ADDENDUM NO. 2

February 23, 2022

**DOUGLAS MACARTHUR ELEMENTARY SCHOOL ADDITIONS,
RENOVATIONS, AND RELATED WORK
Crown Point, IN 46307**

This Addendum consists of Pages ADD 2-1 through ADD 2-2 and attached Addendum No. 2 from Gibraltar Design dated February 21, 2022 and consisting of 7 pages, Specification Section 12 25 00 - Roller Shades and 52 drawings.

1 TELECOMMUNICATIONS BACKBONE DIAGRAM NTS

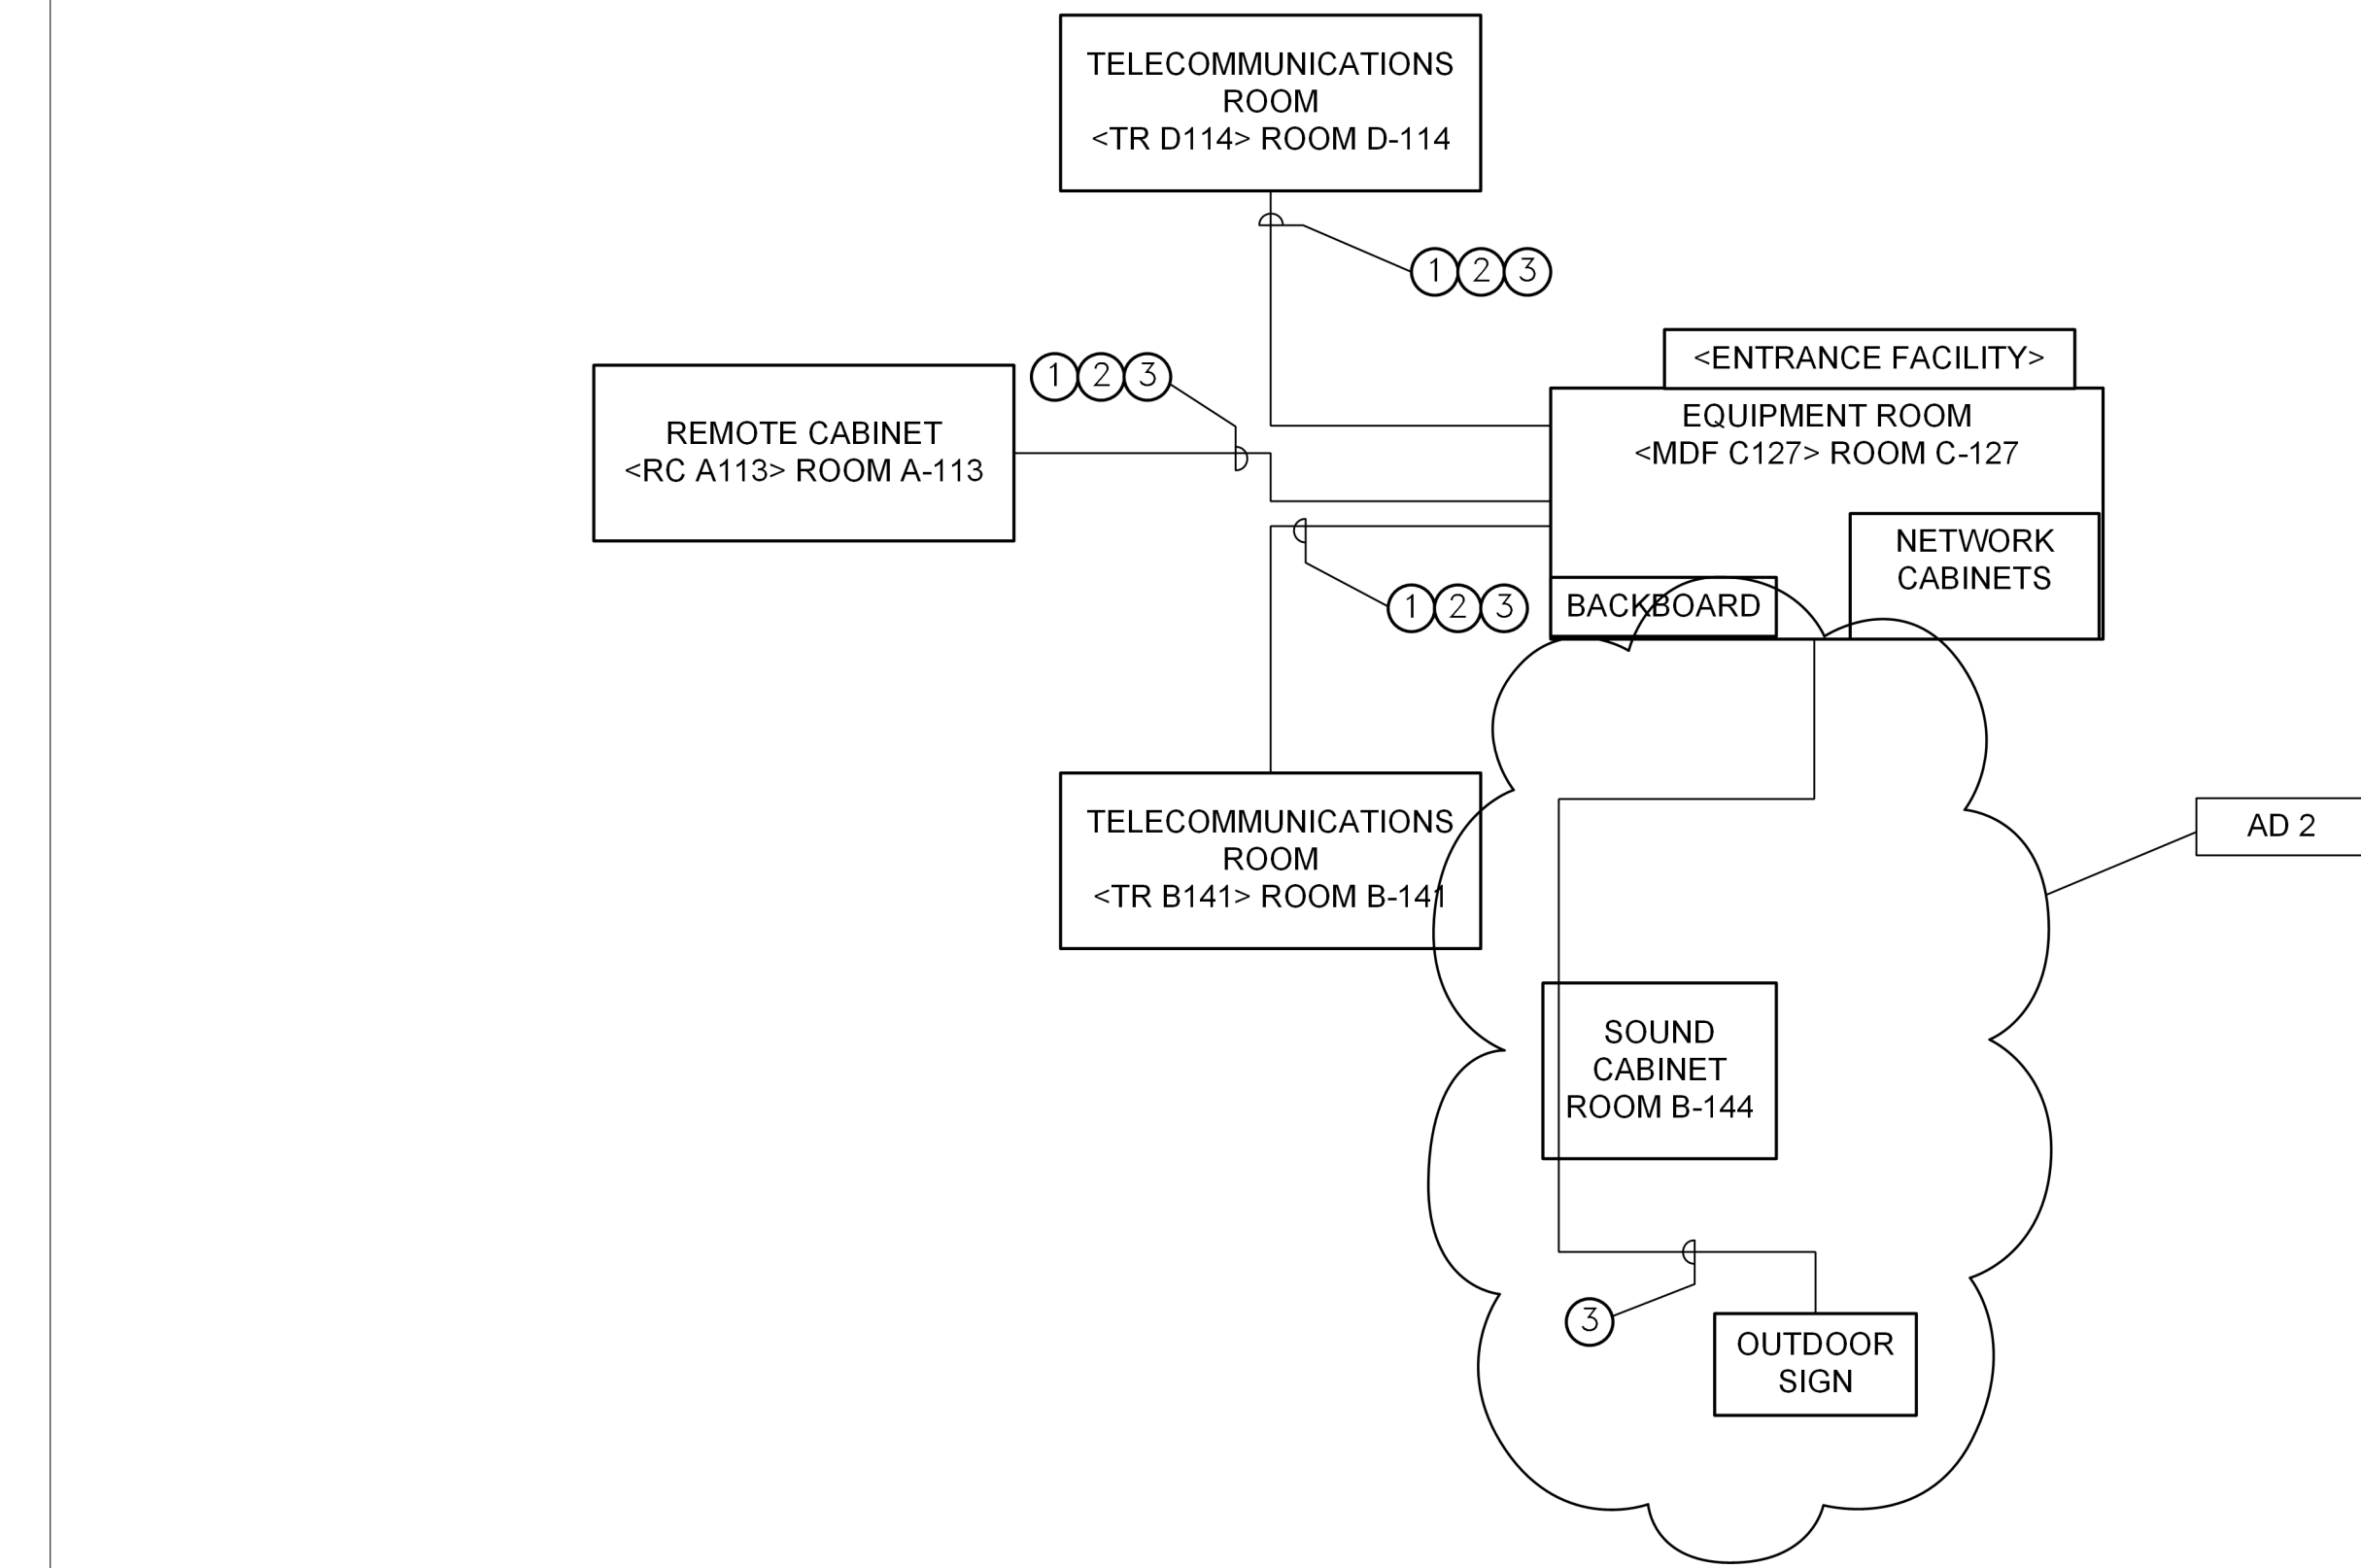
- A. Refer to revised, full size drawing, included in this Addendum, for the following revisions:
 - 1. Add fiber optic cable for outdoor sign to be backbone diagram.
